ADDENDUM NUMBER THREE (3)**CATAWBA COUNTY****BLACKBURN RESOURCE RECOVERY FACILITY OPERATOR'S BUILDING****PROJECT NO. 26.00701**

This Addendum Number 3 (Three) is issued this the 28th day of October 2026, to all parties who hold a set of Bid Documents for the project entitled: “**BLACKBURN RESOURCE RECOVERY FACILITY OPERATOR'S BUILDING**”. This Addendum Number 3 (Three) shall become part of the Contract Documents and its receipt acknowledged on the bid documents at the time of bidding.

DATE:
08-25-26
ISSUE

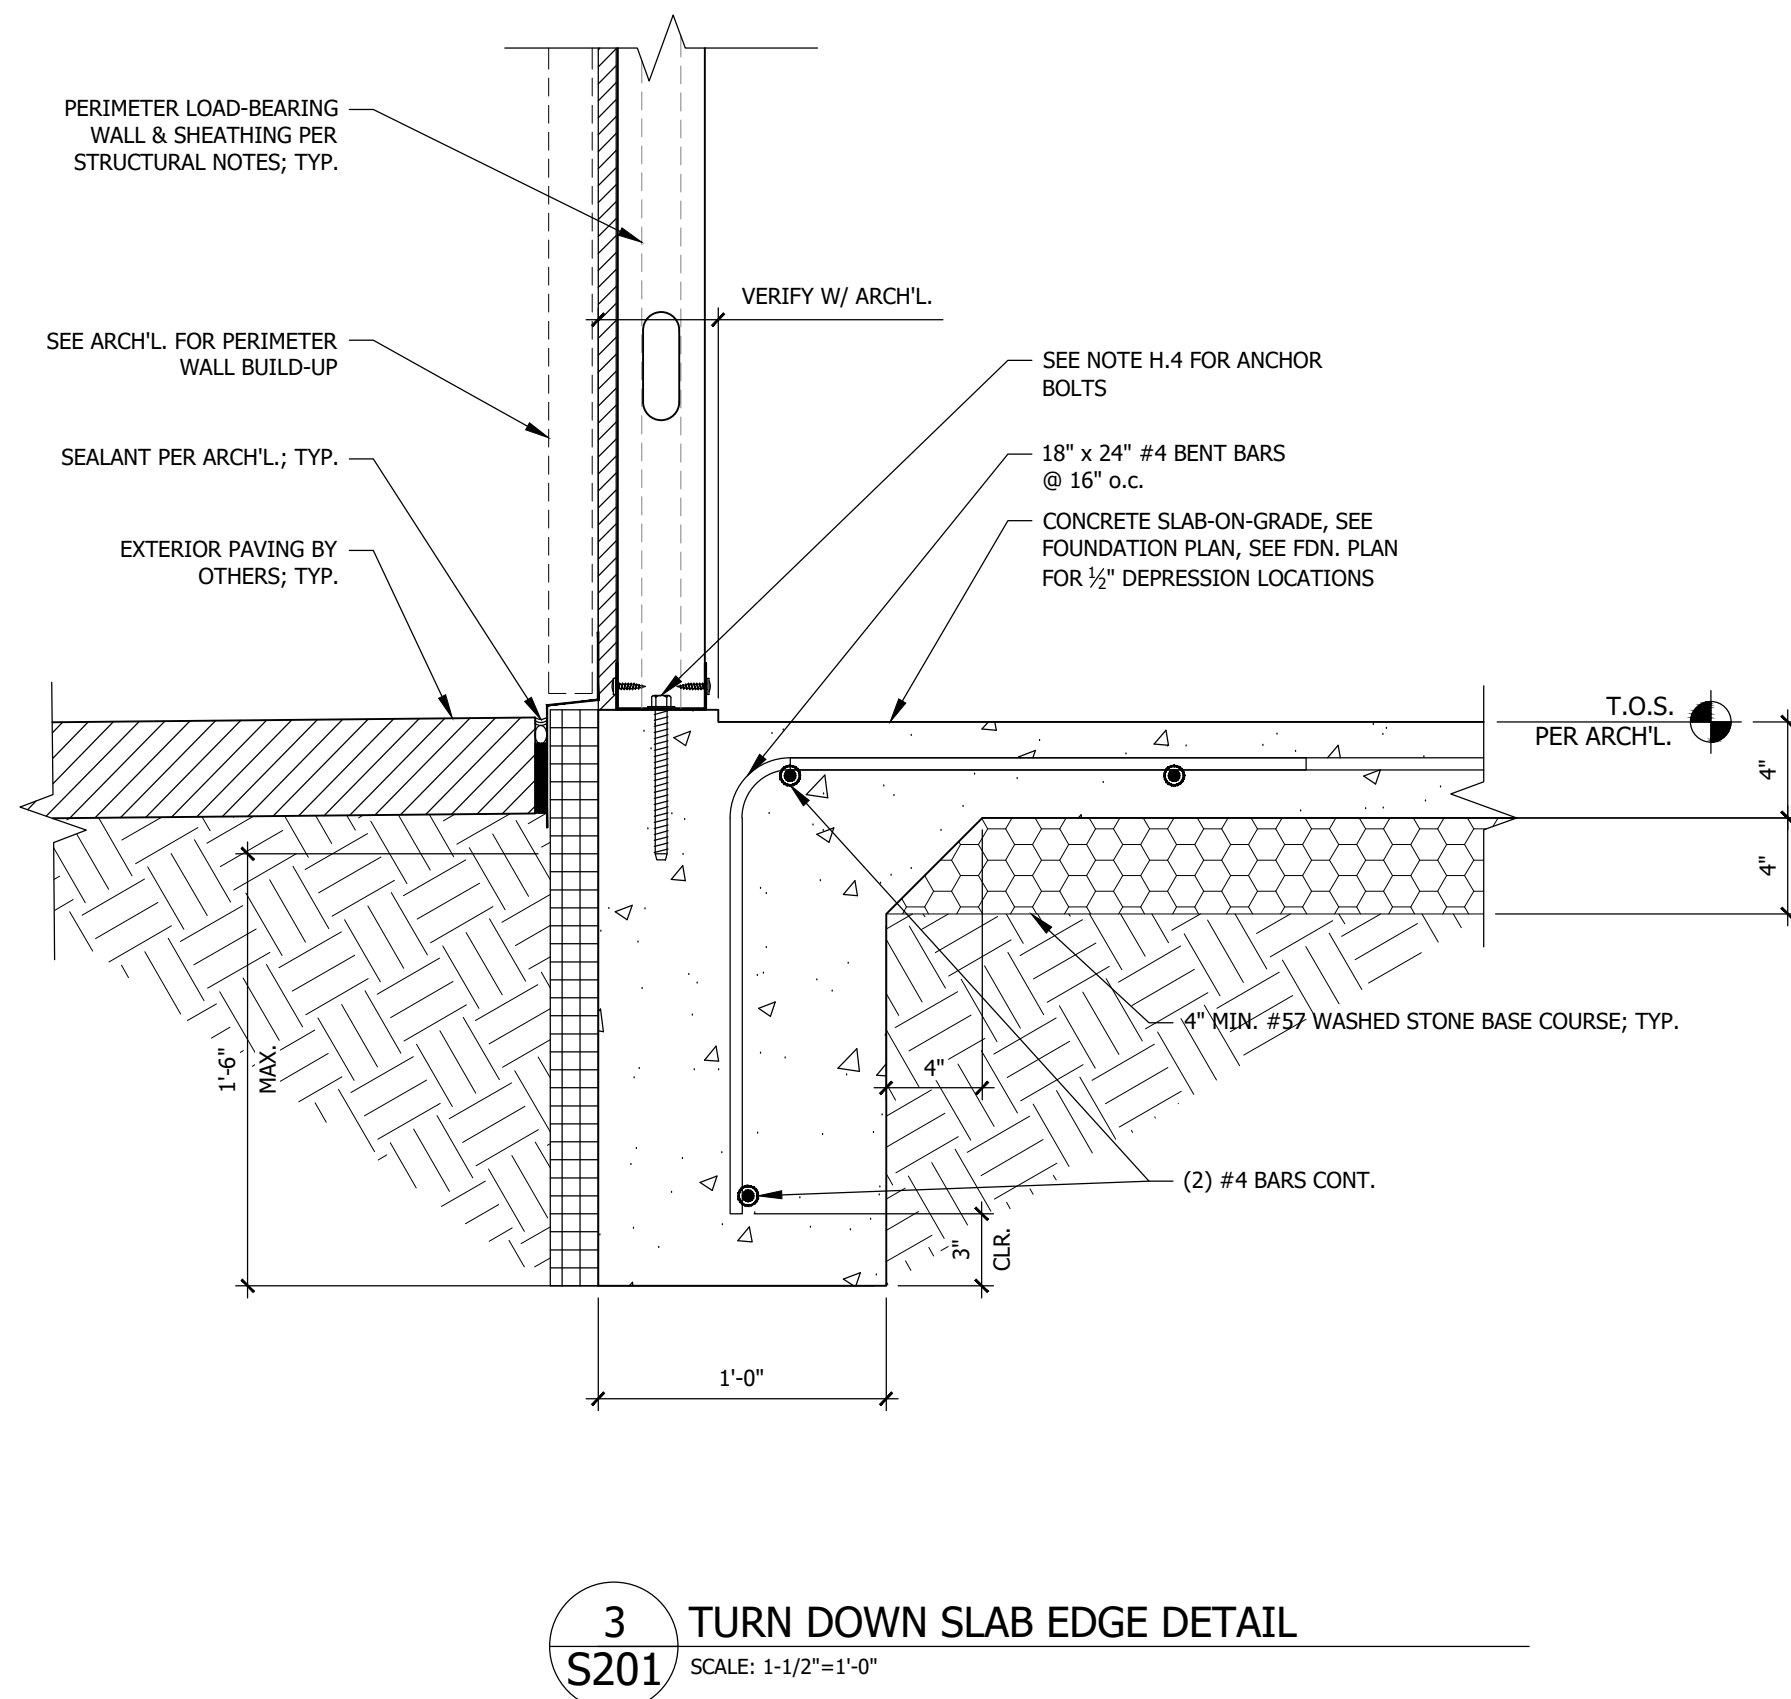
14. On plan sheet S-101, framing note #1, there is a shearwall schedule noted to be on plan sheet S0.3. There is not a shearwall schedule in the structural plans, and we could not find one anywhere in the plans. Could someone please let us know where the shearwall schedule is located.

30. Missing shear wall schedule and details: Sheet S101 references Sheet S0.3 for the plywood shear wall schedule, hold-down requirements, and strapping details. Sheet S0.3 was not included in the provided structural drawing package. Please provide the missing schedule and details, including shear wall locations, sheathing requirements, hold-downs, and strapping. (Reference: S101, Framing Plan Notes 1–3)

- a. Upon consideration, the shearwall note will not be applicable on this project. The steel track shall be attached to the slab per Note H-4 ($\frac{1}{2}$ " diameter x 6" Titan

screws at 32" on center). Structural sheets have been revised to reflect this clarification.

- a. Our reference notes have been corrected. No designated shear walls required for this building.

- FRAMING PLAN NOTES:
- NO DESIGNATED SHEAR WALLS ARE REQUIRED FOR THIS PROJECT.
 - ALL PERIMETER LOAD-BEARING WALLS AND SHEAR WALLS STUDS ARE TO BE FULL HT. AND SHALL BE BALLOON FRAMED FROM PLATE TO PLATE, THERE SHALL BE NO SPLICES AT CEILING JOISTS.
 - TYPICAL PERIMETER LOAD-BEARING EXTERIOR WALL STUDS SHALL BE 600S162-54 W/ 600T150-54 TRACK.
 - SEE ARCH'L DRAWINGS FOR ALL WINDOW AND DOOR OPENING LOCATIONS AND REQ'D. ROUGH OPENING SIZES; TYP..
 - SEE ARCH'L FOR INTERIOR PARTITION WALL TYPES AND LOCATIONS; U.O.N. TYP.
 - VERIFY ALL WALL PLATE ELEVATIONS WITH ARCH'L DWGS.

SHEET TITLE
REFLECTED CEILING
PLAN & ROOF PLAN

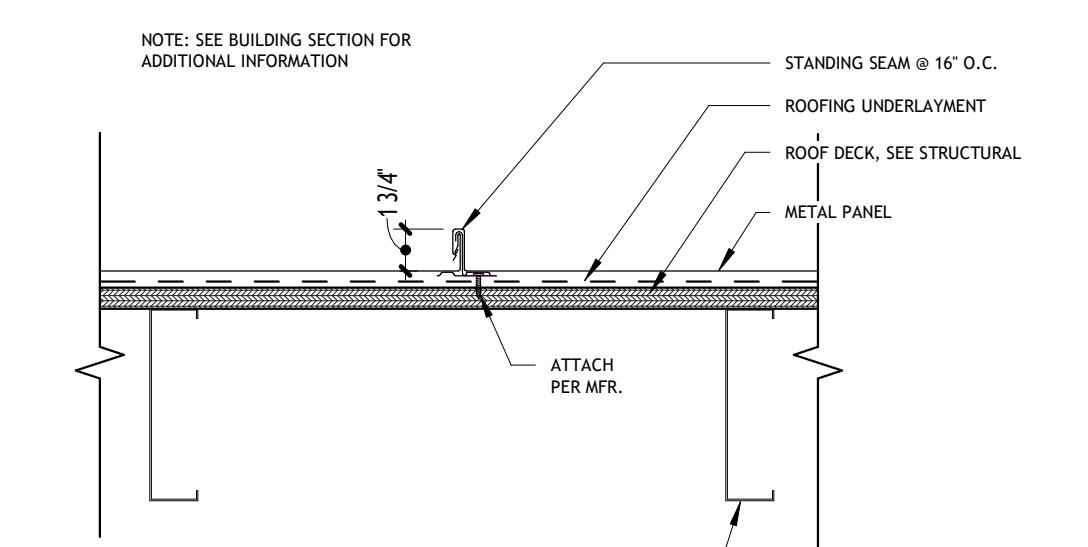
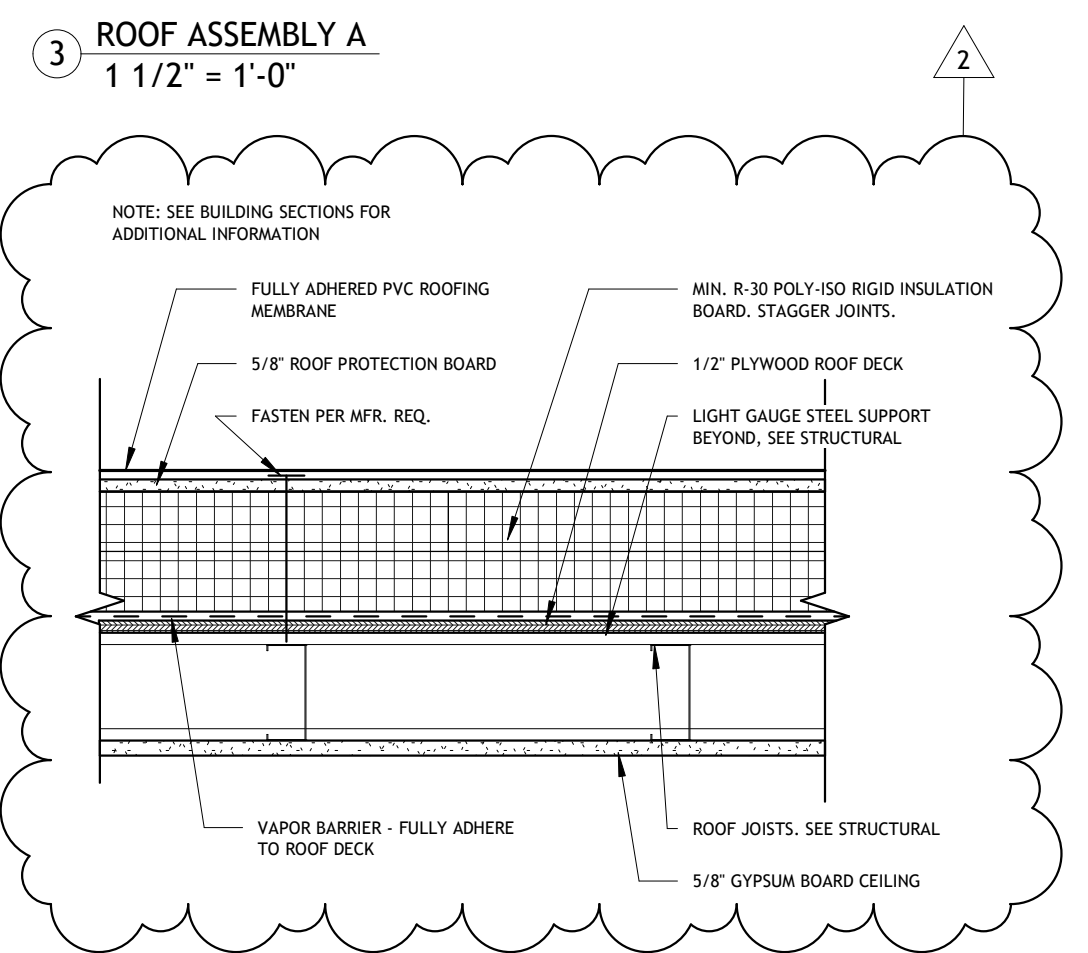
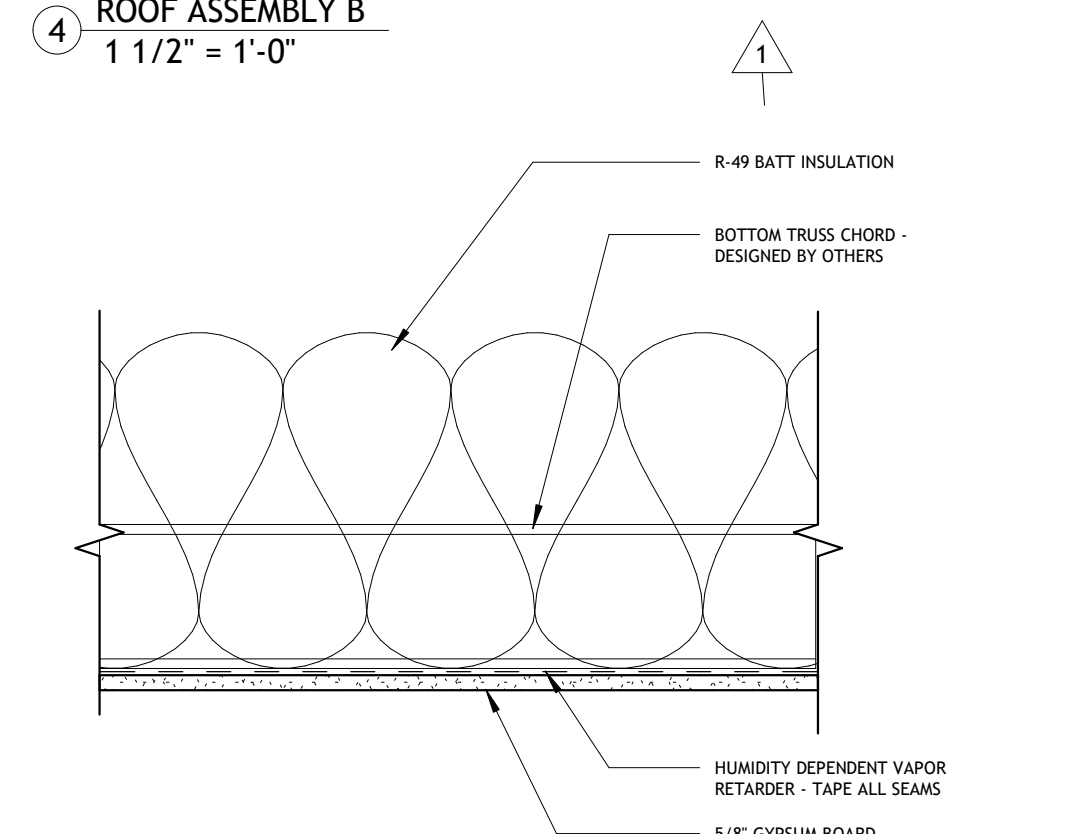
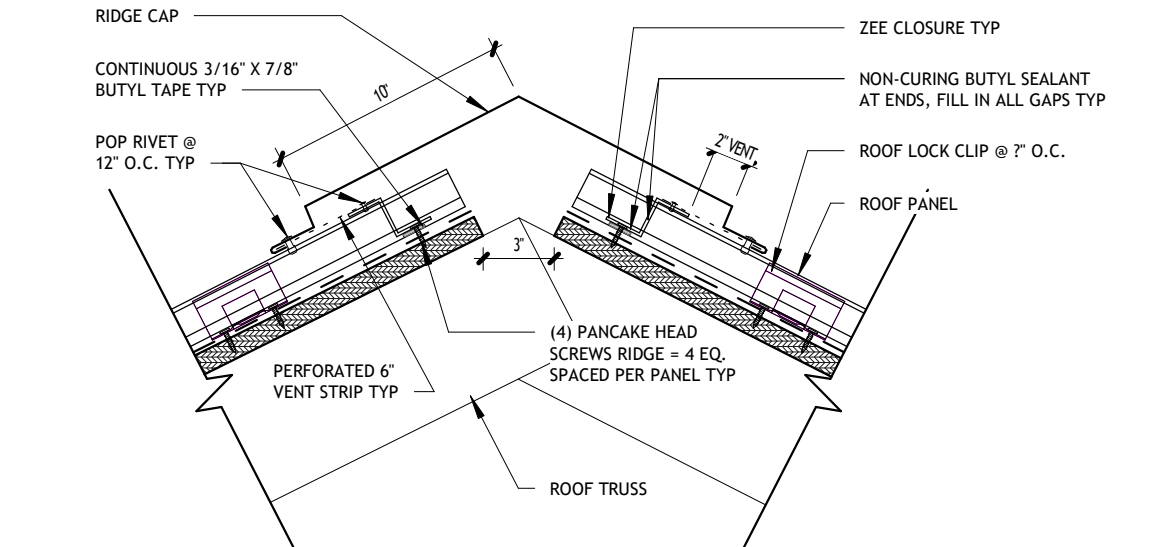
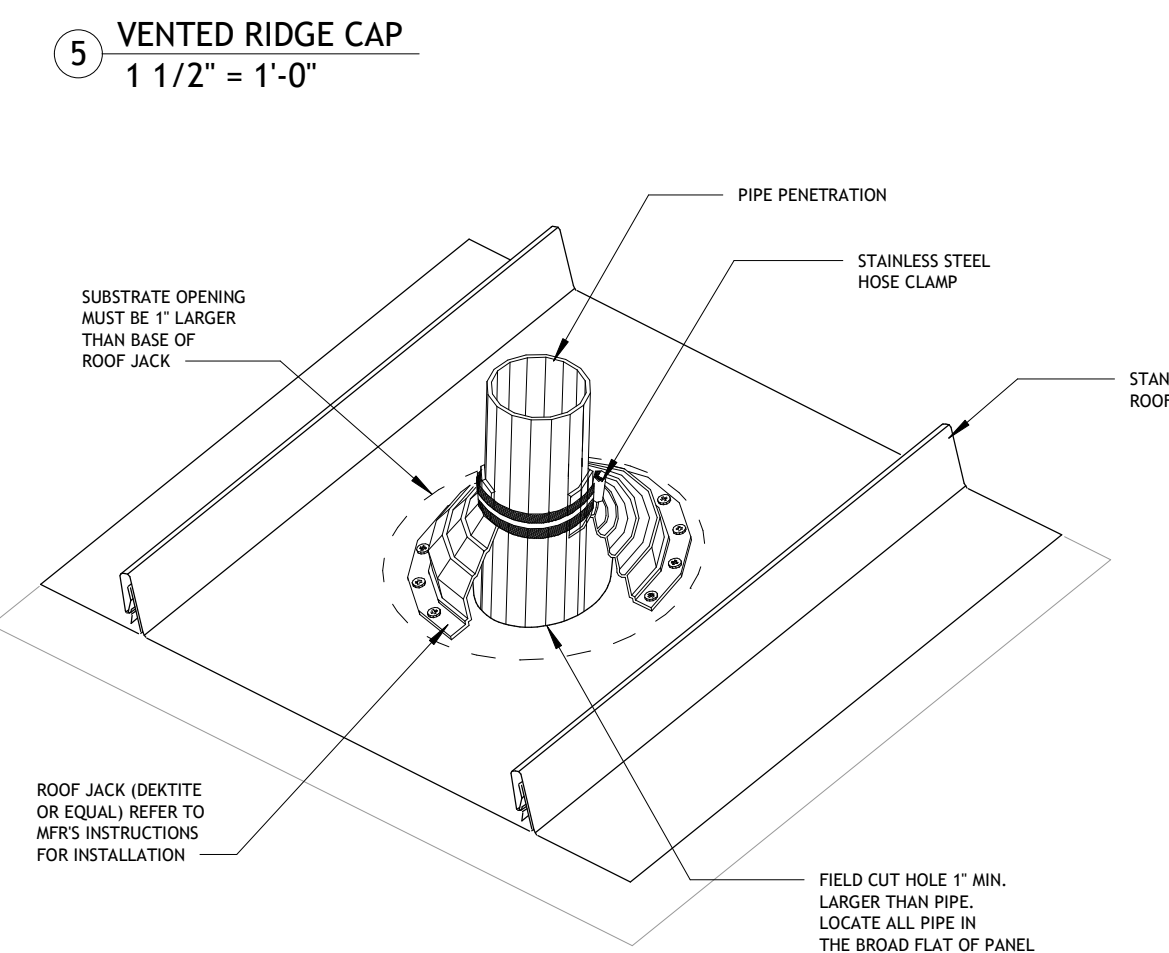
- a. *Sheet A110*: Revisions made to Roof Assembly B.
 - b. *Sheet A310*: Revisions made to details 14, 17, and 18 clarifying changes to Roof Assembly B.

27. There is a minimum order amount for the insulated roof panels (approx. 500 sf). Is there a requirement to use insulated roof panels over the two very small roofs (approx. 75 sf on area)?

- a. Engineer of Record will need to review signed and sealed roof truss package to ensure substantial resistance for attachment to walls.
34. Ceiling joist framing and support conditions: Architectural Roof Assembly B identifies 3-5/8-inch minimum 20-gauge ceiling joists at 16 inches O.C. Please confirm the required support and connection details, permissible spans, and whether these members are structural ceiling joists or non-load-bearing ceiling framing. (Reference: A110, Roof Assembly B; Specification 09 22 16, 3.03)

35. Roof decking and sheathing responsibility: Section 054400 references Section 061000 for roof sheathing, while architectural roof assemblies include different roofing systems. Please confirm the required roof decking or sheathing for each assembly and identify the responsible trade. (Reference: A110; Specification 054400, 1.02(B))

- a. Please see the attached revised Sheets A110, A310, and A401 showing a revised Roof Assembly B and the attached specification Section 074500.
28. CMFM delegated design and shop drawing requirements: Please confirm that the structural cold-formed metal wall framing has been fully designed by the Engineer of Record and that delegated structural engineering is not required. Specification Section 05 40 00 requires shop drawings; please confirm whether signed-and-sealed calculations are required for wall framing. (Reference: S001, S002, S101; Specification 05 40 00, 1.05.)

- a. Please see revised Sheet A110 in Addendum No.3. The roof framing must consist of structural members. Please refer to Sheet S101 for additional information.

- a. The structural roof sheathing shall be 5/8" rated sheathing. Please see revised Sheet A110. Both roof assemblies to use structural plywood roof sheathing. See structural drawings for additional information.

WINDOW ELEVATIONS 1/4" = 1'-0"

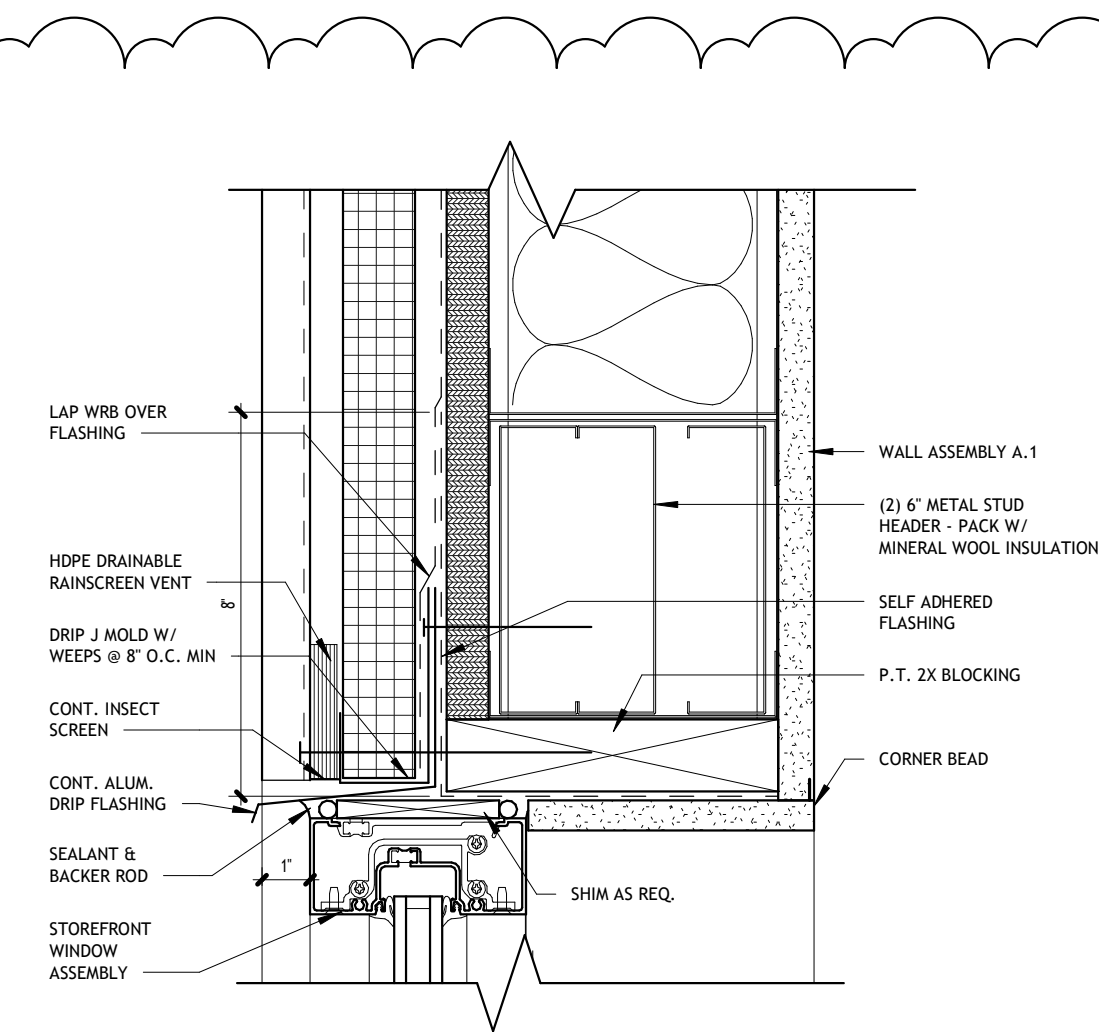
19. Do the aluminum windows have casements?
 - a. The aluminum windows have been revised to be fixed. Please see the attached revised sheet A401.
20. Plumbing pipe material preferences? Copper vs. Pex vs. PVC vs. Cast Iron

25. Addendum No.1 suggests the windows will be revised to be fixed aluminum storefront window forthcoming in Addendum No.2. However, Addendum No.2 does not address this matter.

1. The minutes from the pre-bid meeting in Addendum No. 1 mentioned that more information would be provided on the aluminum-clad wood windows. Please see below.
 - a. After further consideration, the operable windows have been replaced with fixed storefront windows. Please see revised Sheet A401 for further information.

- a. Addendum No. 2 was pushed through prior to all questions being answered in order to notify potential bidders as soon as possible of the change in the bid opening and question deadline. Additional information on the windows have therefore been included within this addendum. Please see the attached revised Sheet A401.

9 STOREFRONT WINDOW HEAD 3" = 1'-0"

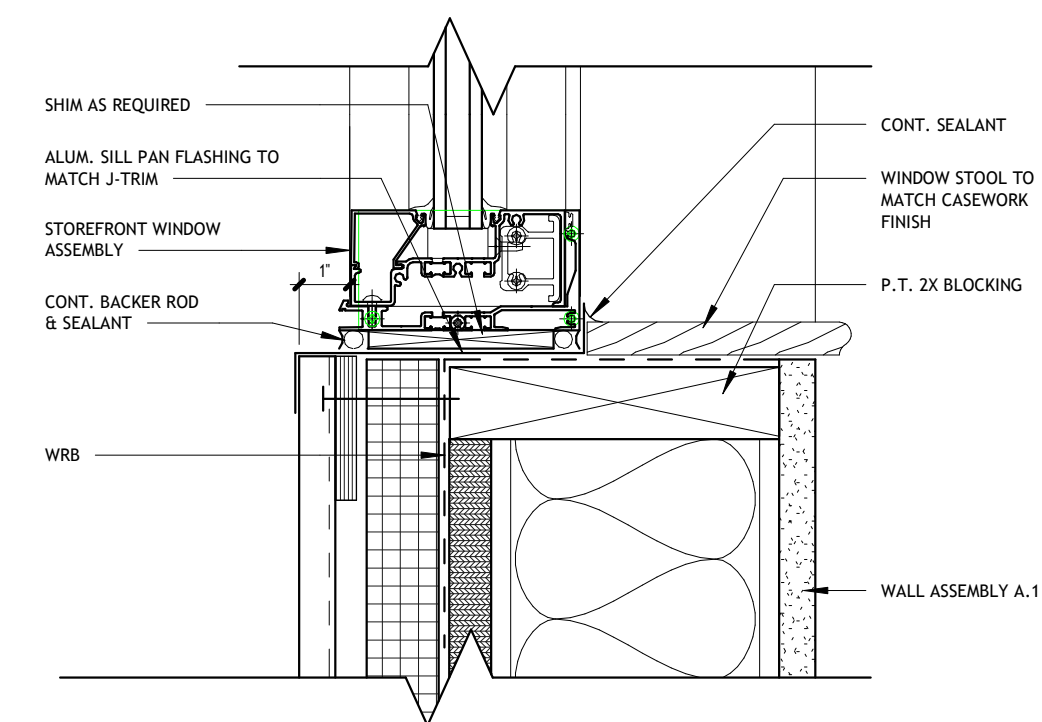
- c. *Sheet A410*: Revisions made to details 9, 10, and 15 clarifying changes in the required window type.
 - d. *Sheet S001-S301*: Revisions made to notes on wall anchoring system.
